MILITARY SPECIFICATION

MICROCIRCUITS, DIGITAL
TTL, BISTABLE LATCHES, MONOLITHIC SILICON

This amendment forms a part of Military Specification MIL-M-38510/15A, dated 27 July 1979, and is approved for use by all Departments and Agencies of the Department of Defense.

FIGURE 3. Logic diagram and schematic circuits for device type 04 - Continued.

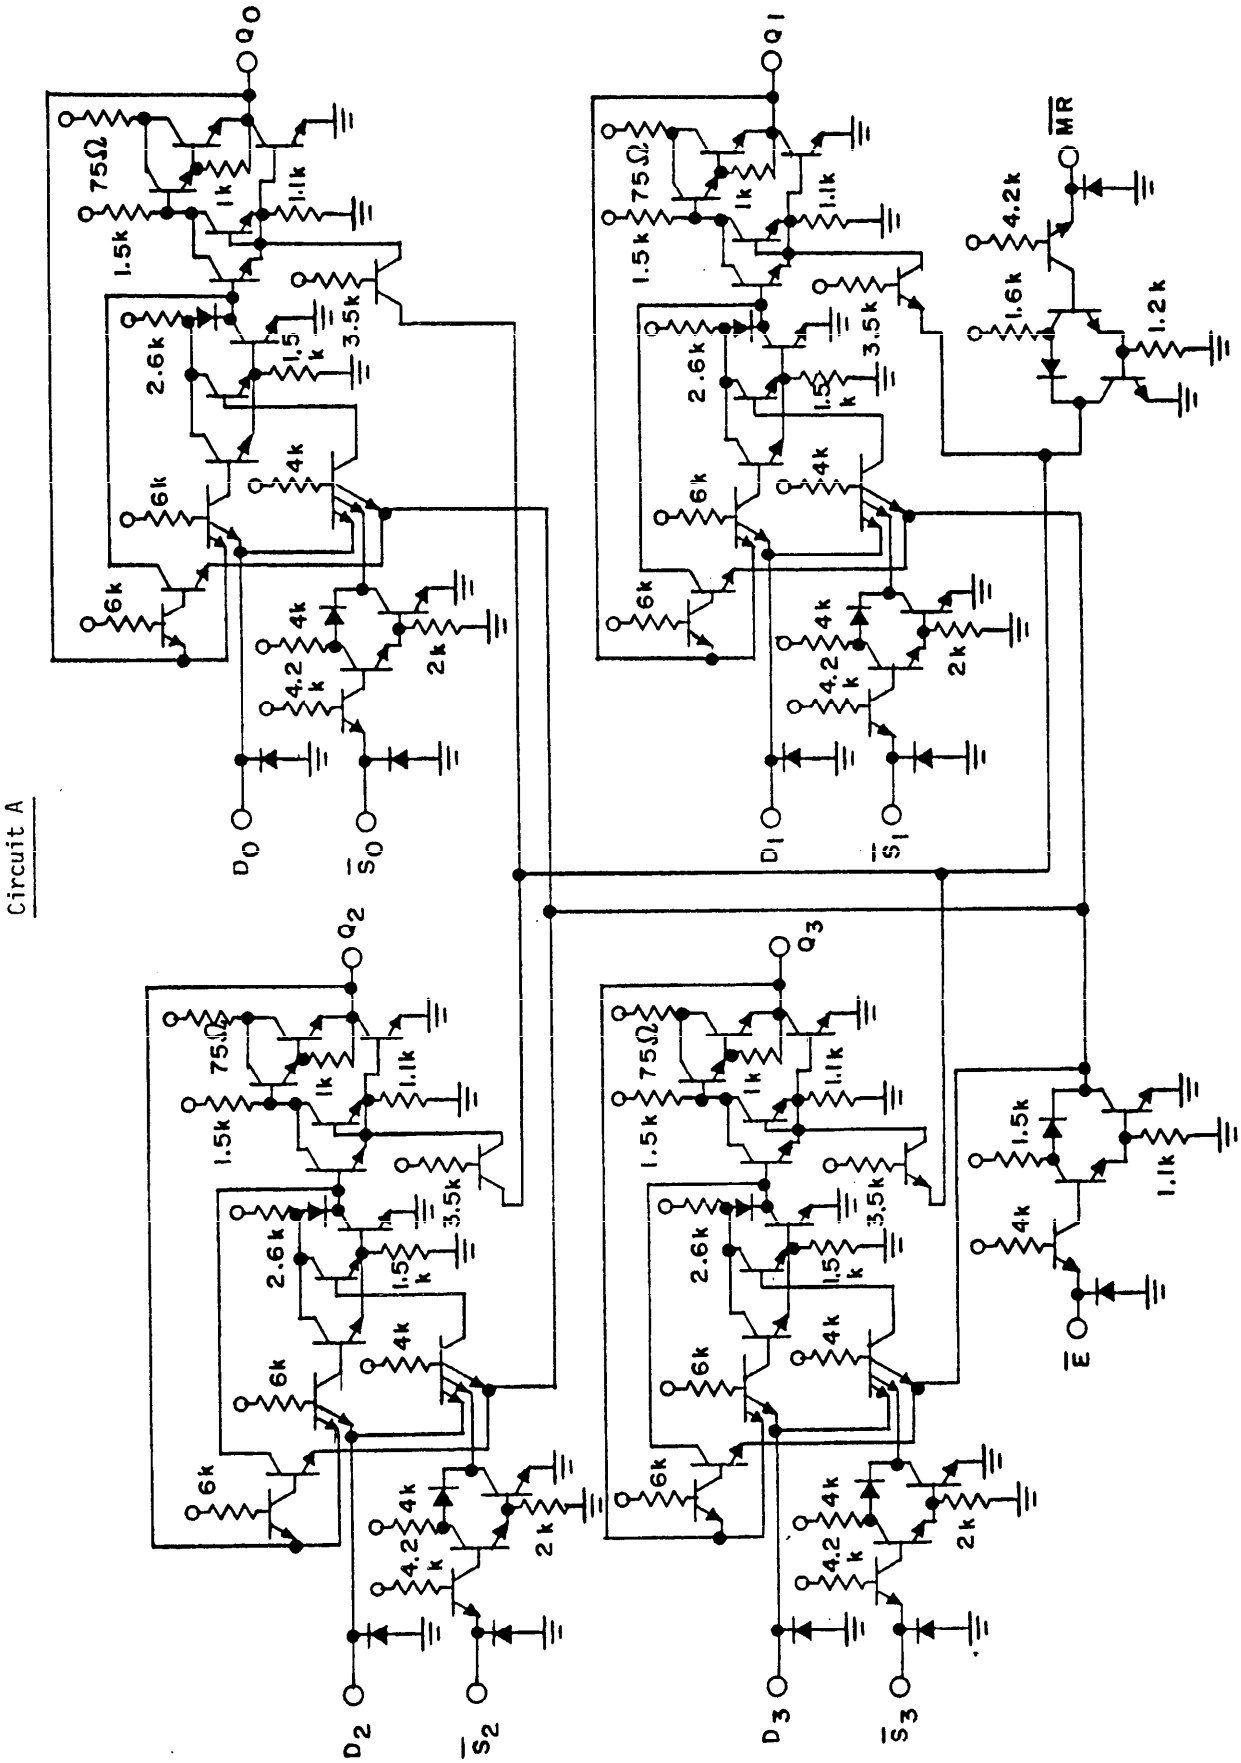
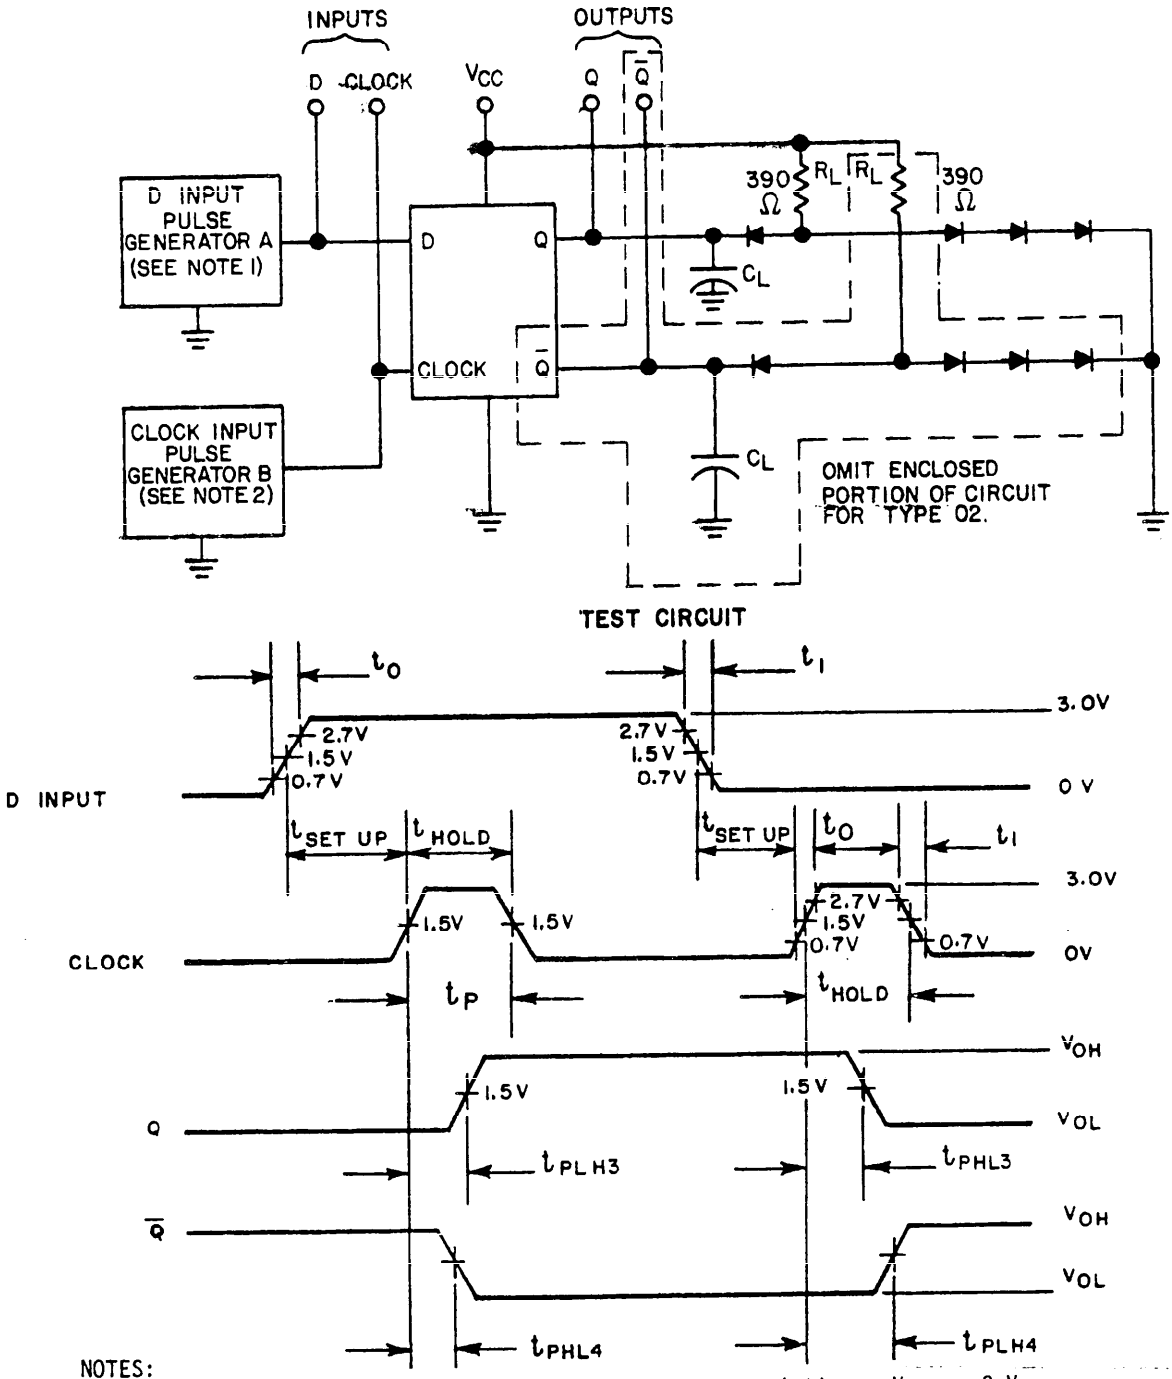
FIGURE 3, delete and substitute new figure as printed on page 2 of this amendment.
